North Ryde Station Site North Infrastructure Works Development Application

Transport impact assessment

20 February 2014

Figure 5.3 Previous Station Site north and south internal street layout

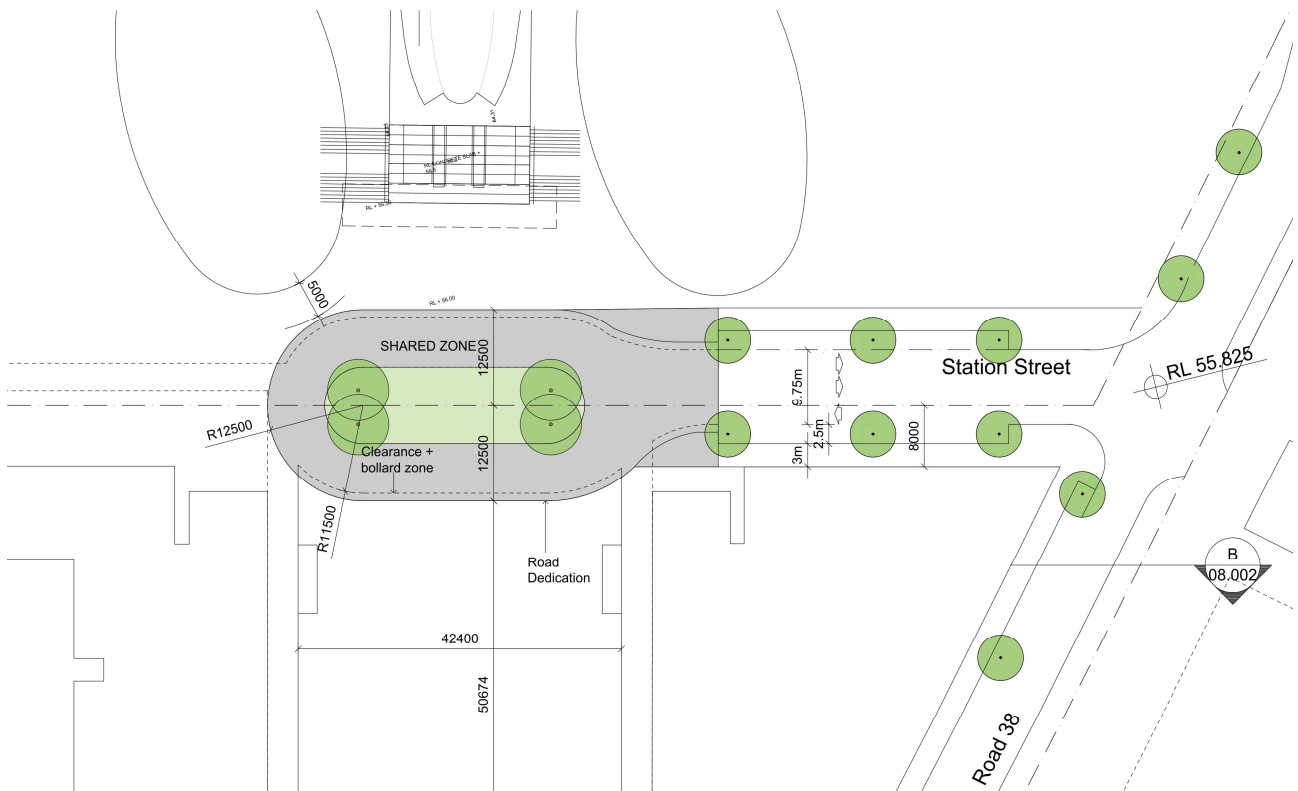
Following discussions with Goodman Property Group and Urban Growth NSW, a revised layout for the Station Street turning circle and access streets has been proposed. The changes include:

- modifications to the shape and dimensions of the turning area
- extension of the shared zone providing access to the western portion of the site
- removal of the pedestrian crossing east of the turning area and addition of a pedestrian crossing on Road 38 south of Station Street
- removal of the central swale within Station Street.

The reduction in the forecast queue length from the Delhi Road traffic signals means that queuing back into the turning circle is no longer of concern. SIDRA modelling for the intersection of Road 38 and Station Street indicates that queuing at this intersection is forecast to be minor. The previous turning circle is shown in Figure 5.3, while the new shape and dimensions are shown in Figure 5.4.

Parsons Brinckerhoff has reviewed the proposed design modifications against the access requirements of service vehicles and identified access issues if a future entry to North Ryde Station is opened from the Station Street level. The issues identified are listed in Table 5.1

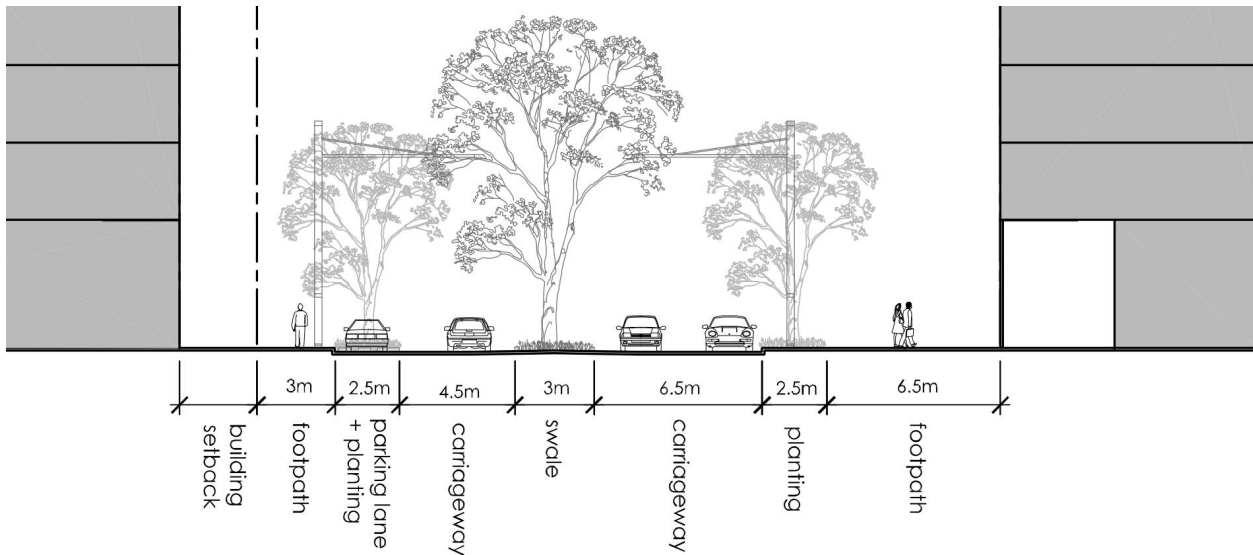
Design element	Design requirement	Issue
Turning circle dimensions	<p>City of Ryde Council has advised that the turning circle should be designed to accommodate its garbage collection vehicle (8.8 m long) and large rigid removalist vans (12.5 m long).</p> <p>Transport for NSW indicated during the TMAP process that the turning area should be designed to accommodate rail replacement buses (12.5 m standard length).</p> <p>Access is required for NSW Fire Brigades appliances.</p>	While the turning area has been designed to the requirements of City of Ryde Councils' Environmental Standards Development Criteria Section 4 Public Civil Works, an analysis using AUSTRROADS swept path templates indicates that 12.5 m vehicles cannot fit around the turning area and an 8.8 m service vehicle is required to make a mandatory stop within the turning circle and turn on full-lock – typically an unacceptable solution for a public road.

Elongated shape	Design should be understandable and encourage the intended behaviour.	The elongated design and its proximity to the proposed future station entrance gives the impression that it is a drop-off and pick-up area. If vehicles do dwell in the turning area, other vehicles will not be able to pass due to the tight geometry. This would increase delays for vehicles attempting to turn around and vehicles exiting the building to the west of the station.
	The design should minimise the impediment for pedestrians walking to/from the planned station entry.	The elongated shape increases the area where vehicles and turning vehicles interact, prolonging the exposure to a risk of collision. Driver confusion created by the non-standard design may lead to inattention by drivers.
Placement of trees in the central island	Trees should not encroach on the road space clear zone and should not obscure vision of pedestrians for drivers.	The drawing indicates that the tree canopy could overlap into the turning area space. With an already tight design, drivers of trucks or buses attempting to miss the tree could put them off-line to complete the turn in one movement.

The NSW Fire Brigades *Guidelines for Emergency Vehicle Access* indicate that the turning circle radius required for a general appliance vehicle is a minimum of 11.3 m, while the turning circle required for an aerial appliance is 14.6 m. As the proposed development is high-density residential apartments, it is conceivable that aerial appliances may be required in the event of an emergency.
